CHANGE

MODIFICATION WORK ORDER

MODIFICATION OF 1-1/4 TON VEHICLES

M998 SERIES

FIGURE 1

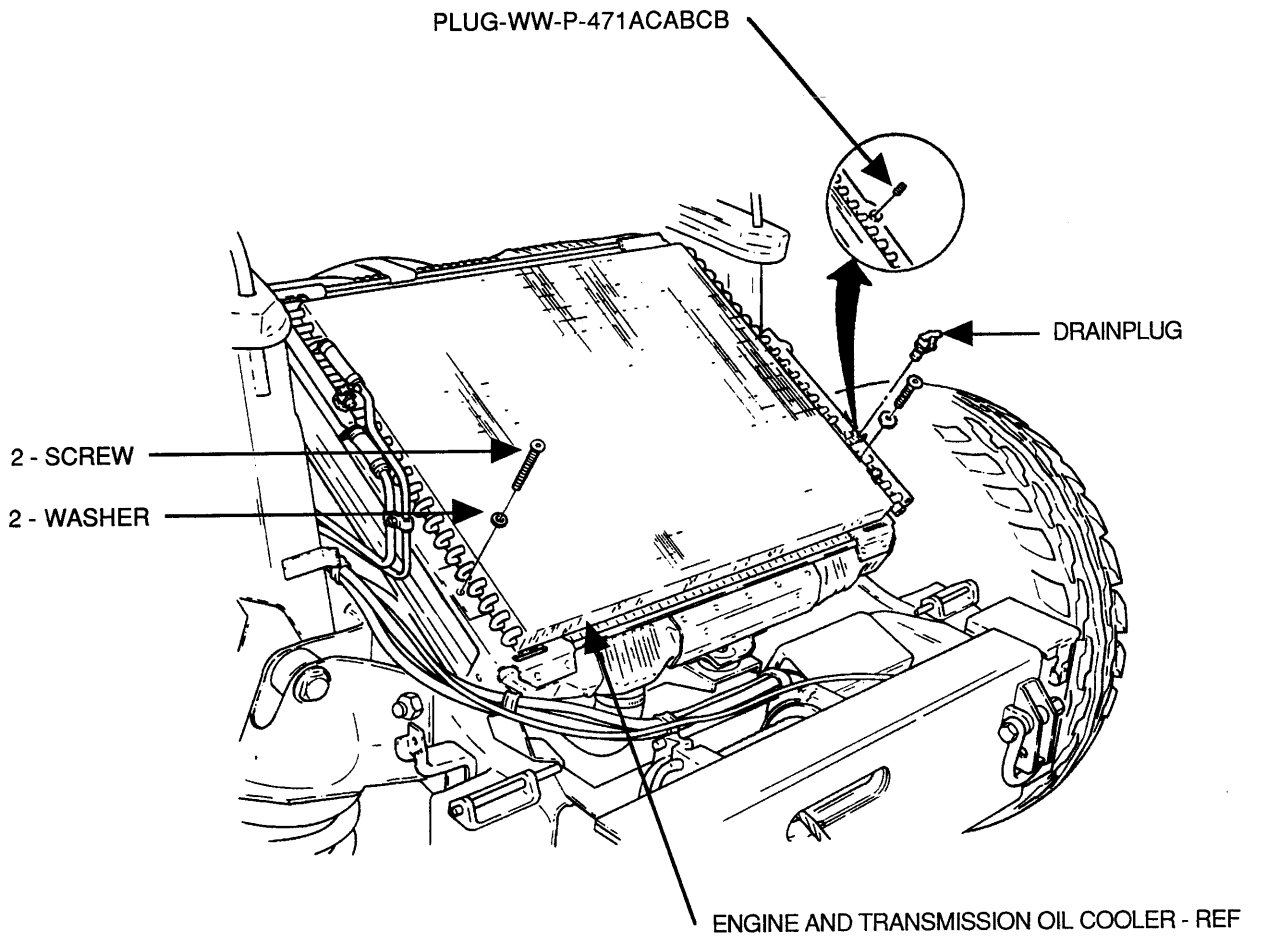
- (1) Disconnect battery ground cable. (Refer to TM 9-2320-280-20.)
- (2) Remove hood. (Refer to TM 9-2320-280-20.)
- (3) Remove left side splash shield. (Refer to TM 9-2320-280-20.)
- (4) Remove drainplug from oil cooler as shown in figure 1.

- (5) Install WW-P-471ACABCB plug in oil cooler as shown in figure 1.
- (6) Remove two lower screws and washers from oil cooler as shown in figure 1.
- (7) Remove two nuts, washers, screws, and clamps from power steering hoses as shown in figure 2. Save for installation.
- (8) Remove two clamps and hose from control valve elbow and steering gear as shown in figure 2. Save for installation.

FIGURE 3

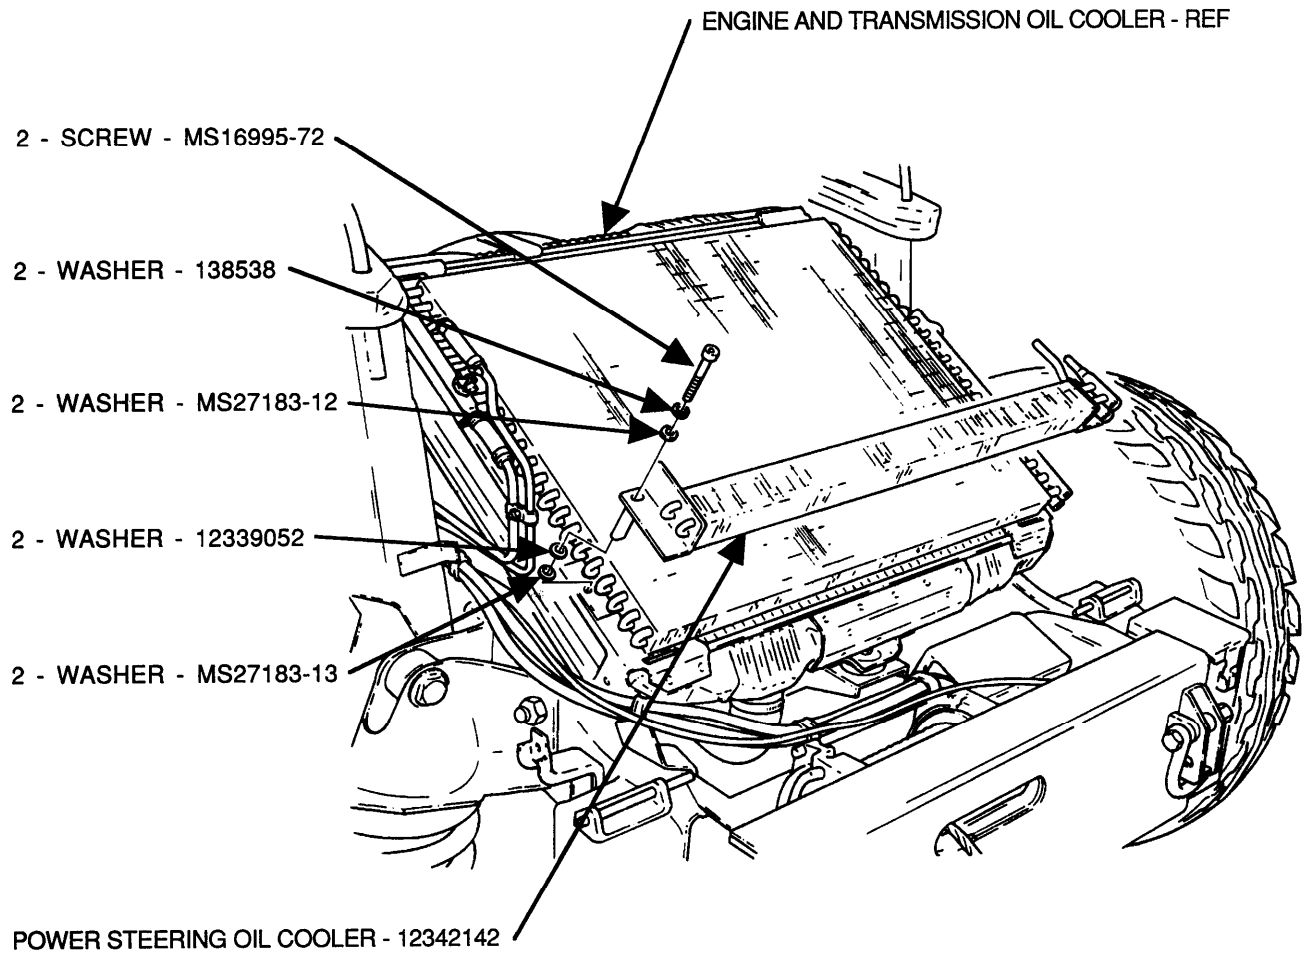
(1) Position two MS16995-72 screws, 138538 washers, and MS27183-12 washers to 12342142 power steering oil cooler as shown in figure 3.

(2) Position two 12339052 washers and MS27183-13 washers to oil cooler as shown in figure 3.

(3) Install power steering oil cooler to oil cooler and secure with two screws as shown in figure 3. Tighten screws to 12-14 lb-ft (14-18 N m).

FIGURE 4

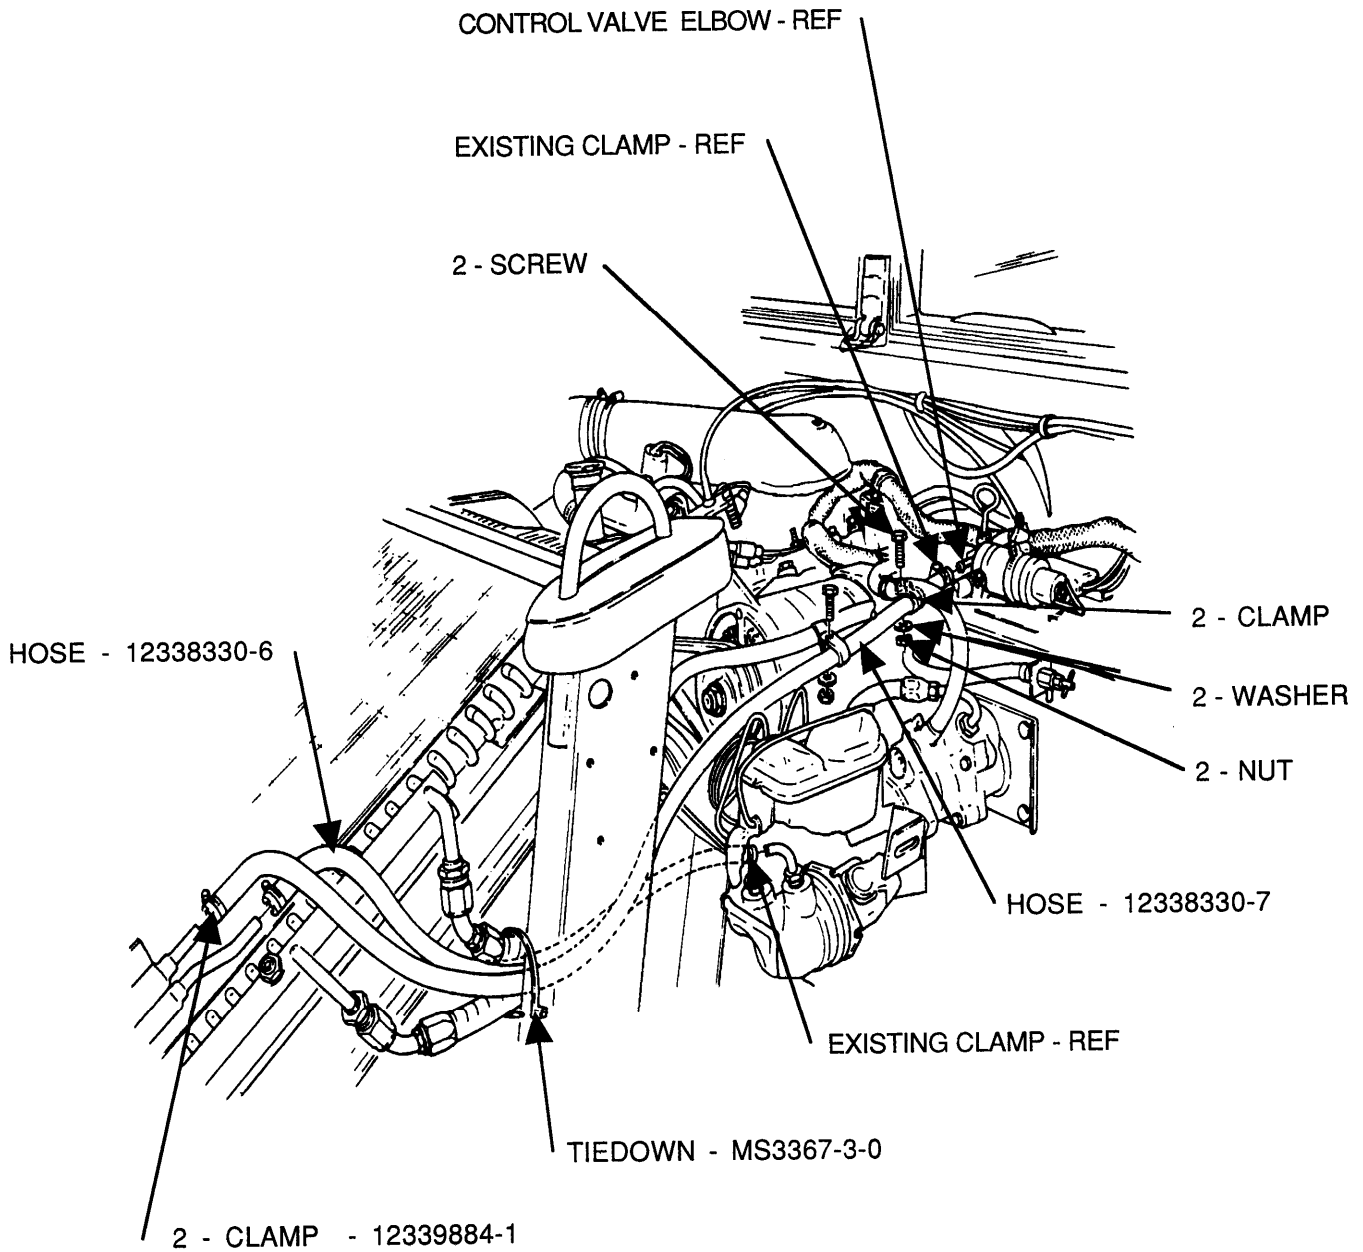
(4) Install 12338330-6 hose to power steering oil cooler and power steering gear and secure with 12339884-1 clamp and existing clamp as shown in figure 4.

(5) Install 12338330-7 hose to power steering oil cooler and control valve elbow and secure with 12339884-1 clamp and existing clamp as shown in figure 4.

(6) Position two existing clamps on hose and secure with two screws, washers, and nuts as shown in figure 4.

(7) Secure hoses with MS3367-3-0 tiedown as shown in figure 4.
